**BUILDING SITE INSPECTION REPORT**  
**SERVICE AND CONTOUR SKETCH**

PROPOSED RESIDENCE FOR: **MD 360**

PROPERTY ADDRESS:  
**LOT 7 (HSE # 6) STOCKWELL WAY  
 KINGSLEY  
 CITY OF JOONDALUP**

Attention: Emily Andrews – Urban Planner

**DEEP SOIL PLAN**

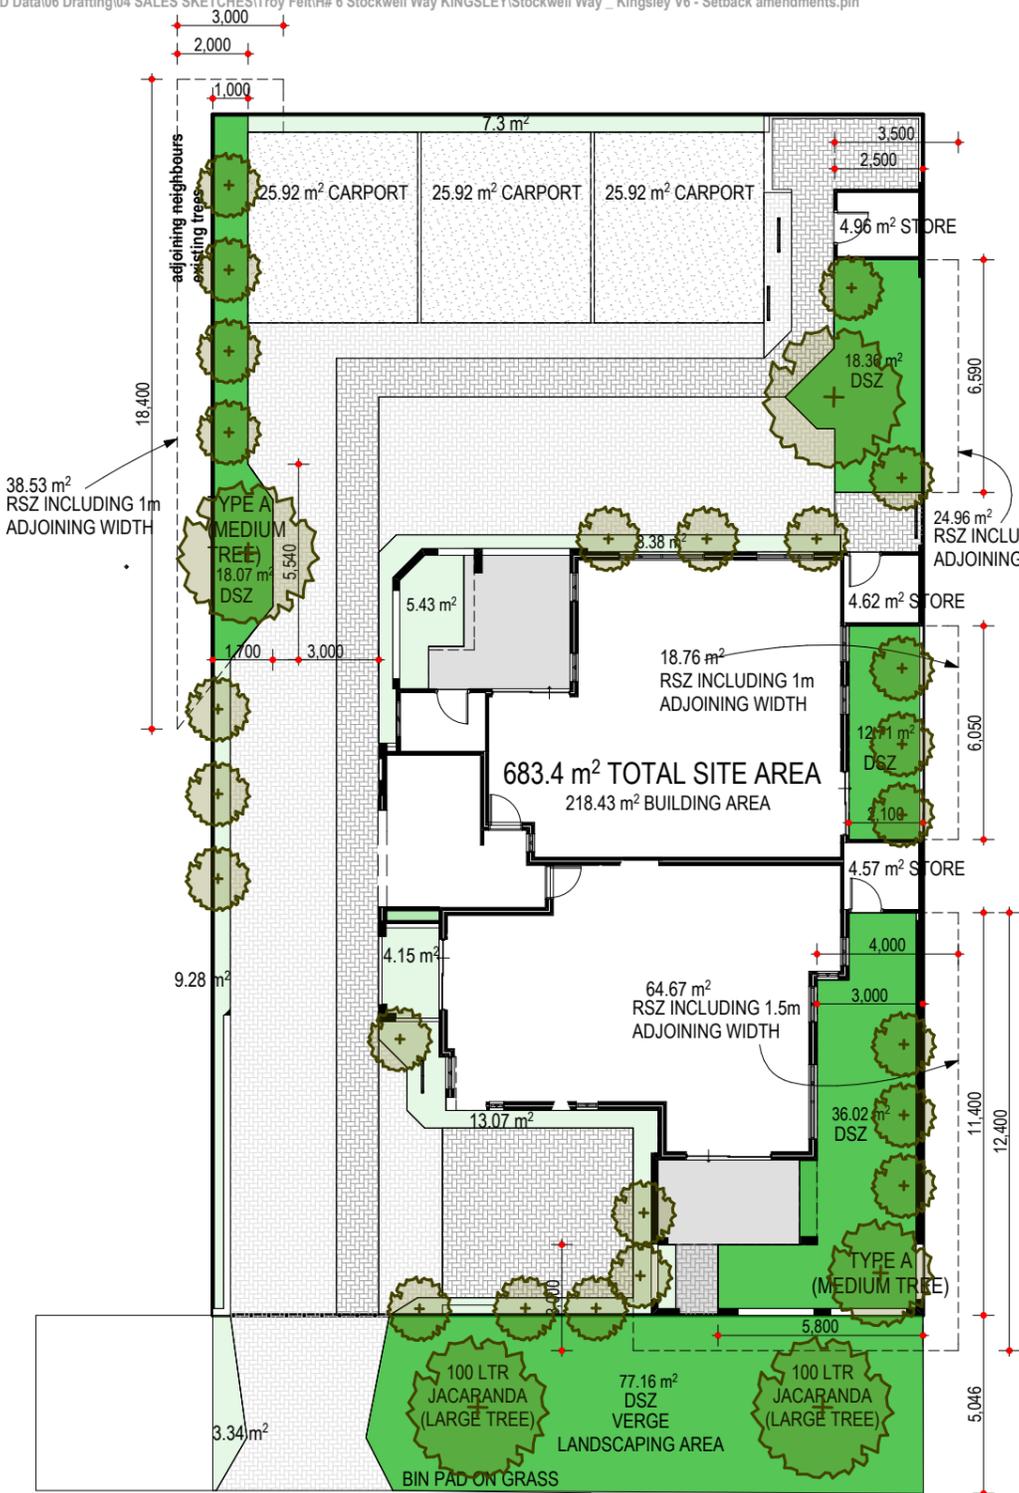
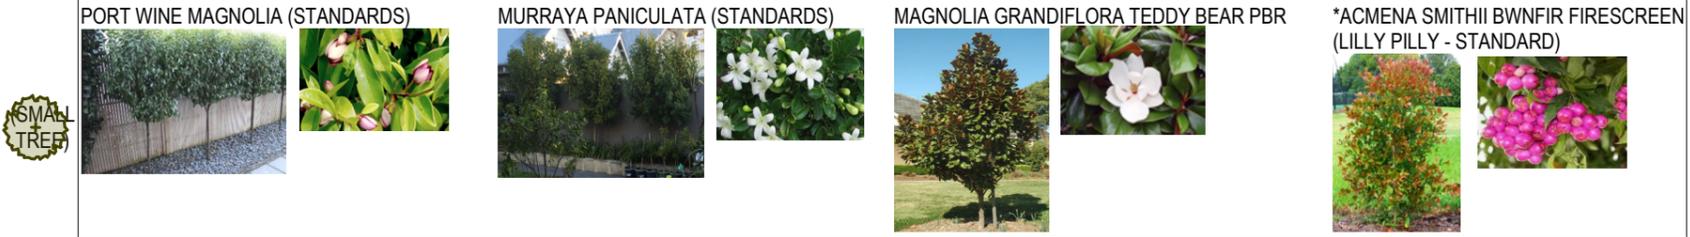
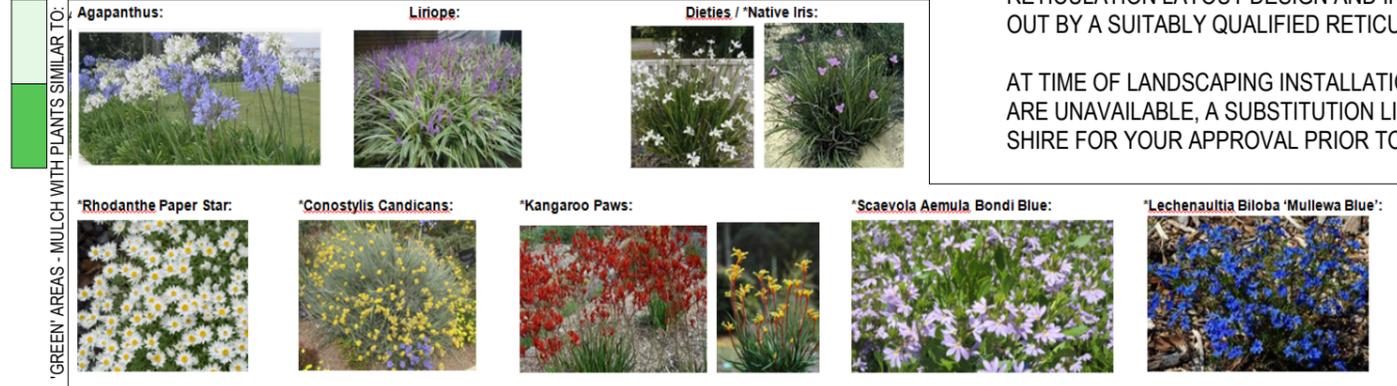
Amended plans have been prepared (see copies attached herewith) illustrating the landscaping areas, deep soils zones, provision of the required trees and an increase to the root soil zones for the development in accordance with the 'acceptable outcomes' of Design Element 3.3 of the R-Codes.
